SERVICE BULLETIN NUMBER: SB-6-44162

SUBJECT: Toyota Hilux and Isuzu D-Max LAT-38-135-H E6 Pedestal Bulletin

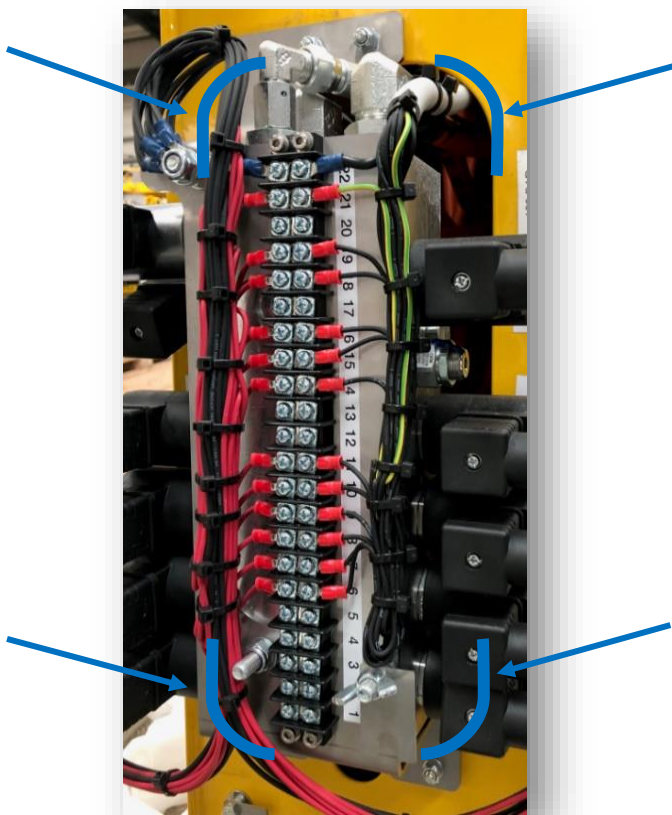
Versalift have identified through routine inspection, in-service reports, and customer feedback the risk of material fracture/ cracking in the pedestal propagating from the valve-bank pedestal oval cut-out radii, as identified in the image below, on the LAT-38-135-H.

This may be attributed to vehicle/ lift mistreatment and misapplication such as overloading however, Versalift ask that in the first instance the end users inspect the areas shown to the left for damage before use.

If cracks, deformation, and/or damage is identified work must be stopped and Versalift informed so that the pedestal can be further inspected.

Further to these checks Versalift have developed a boom rest support to alleviate the potential risk in this area whilst improving the usability, road travel vibration, and bucket docking process post customer feedback.
